Ultramar Inc. - Valero Wilmington Refinery Proposed Alkylation Unit Improvement Project

RESPONSE TO COMMENTS

### **Responses to Comment Letter No. 3**

Figure excerpted from First Quarter 2013 Groundwater Monitoring Report<sup>5</sup>

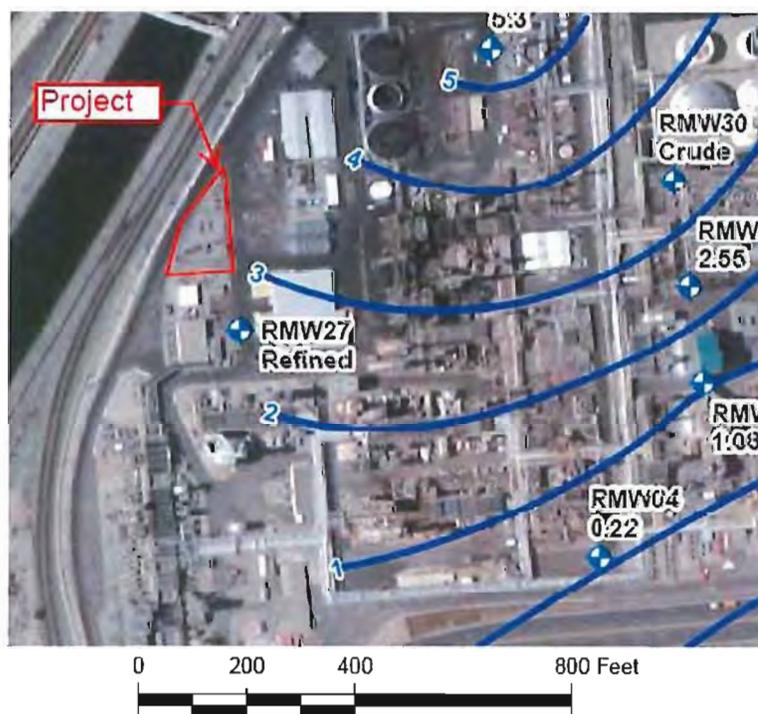
1. The groundwater beneath the Project, where excavation is to take place, is likely overlain by a layer of refined products, i.e. diesel and gasoline. A map obtained from the Geotracker website shows that in the first quarter of 2013, a groundwater monitoring well (RMW27) less than 200 feet away from the Project (see figure below) where excavation is to take

place, contained a floating layer of refined “free product” identified on the map as “refined”<sup>2</sup> Past monitoring in well RM27 has shown high levels of gasoline and diesel hydrocarbons.<sup>3</sup> According to another recent report available on Geotracker, but not referenced in the Neg Dec, “refined product in RMW27 has been present since the well was installed in 1999.”<sup>4</sup> The free product has remained in well RMW27 since it was drilled, based on historical accounts and the fact that the most recent monitoring report (first quarter 2013) documents its presence.

Comment 3-39). The commentators state that the groundwater beneath the Project is “likely” overlain by a layer of refined products (Comment 3-39) but provide no data to substantiate their opinion. Thirty-four acres of the southern portion of the Refinery was formerly permitted by the RWQCB as a disposal site for oil and gas drilling waste (EEC, 2011).

Groundwater has been sampled and tested for petroleum hydrocarbons and related constituents for over 25 years. Groundwater data collected beneath the Refinery has clearly established that only isolated instances of petroleum products are present beneath the Refinery, and that no significant dissolved phase plume of typical petroleum products, such as benzene, toluene, ethyl benzene or xylenes (collectively referred to as BTEX), are present (EEC, 2011). See Section 4 of this response in reference to the depth of the groundwater and Section 5 for the benzene concentration samples. Therefore, the reference in the comments (see Response 3-39) to a shallow layer of gasoline and diesel overlying the groundwater beneath the Project site is not supported by facts gathered as part of the RWQCB monitoring reports. As stated in Public Resources Code (PRC §21082.2(c)) and in CEQA Guidelines §15064(f)(5), “Argument, speculation, unsubstantiated opinion or narrative, or evidence that is clearly inaccurate or erroneous, or evidence that is not credible, shall not constitute substantial evidence.” Information provided by the commentators is clearly erroneous and, therefore, does not constitute substantial evidence.
